REVISED RESPONSE TO REQUEST FOR ADDITIONAL INFORMATION**APR1400 Design Certification****Korea Electric Power Corporation / Korea Hydro & Nuclear Power Co., LTD****Docket No. 52-046**

RAI No.: 287-8272
SRP Section: 09.01.02 – New and Spent Fuel Storage
Application Section: 9.1.2
Date of RAI Issue: 11/02/2015

Question No. 09.01.02-20

Figure 1 Comparison of Rack Top Displacements at the Time Step Sensitivity Runs

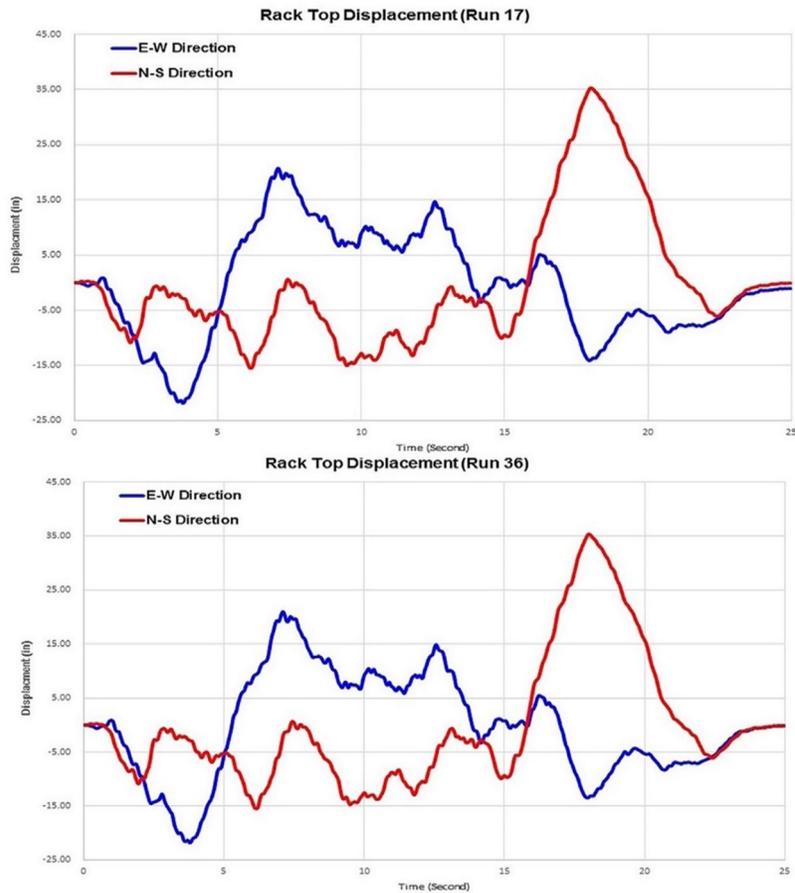
d. Provide the integration time step used in performing the nonlinear time history analyses for SSE. Please explain the sensitivity of the numerical results to the integration time step used in the nonlinear seismic analyses. Provide the results of any sensitivity analysis performed.
